## Remote Link and System Link January 2013

### Version 1.66 Software Update

All Remote Link and System Link software will begin manufacture as Version 1.66 (1/2/13) effective January 17, 2013. This version is an update from the Version 1.66 (10/3/2012) previously shipped and contains updated operation. If your current Remote Link or System Link software is previous to Version 1.46, update to Version 1.59 before updating to 1.66 (1/2/13).

#### Weather Zip Code

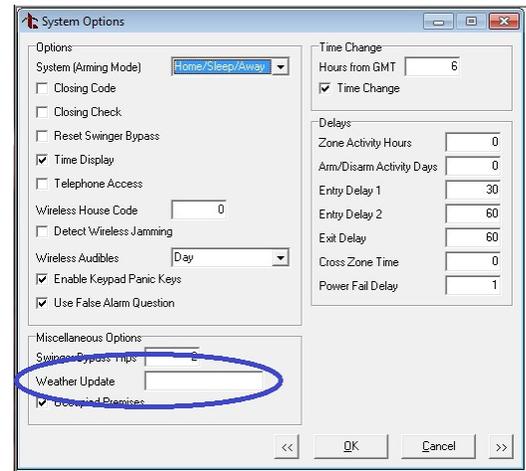
A new option has been added to System Options programming of XT30/XT50 Series and XTL panels using Version 114 software with cellular or network communication to retrieve local weather data. The Weather Update option can be seen in the figure to the right. When connected to the panel, the 7800 Series Graphic Keypad displays the weather data in the form of icons on the main screen. This feature is also available with the DMP 7000 and 7100 Series Keypads. The weather data is displayed as part of the status list.
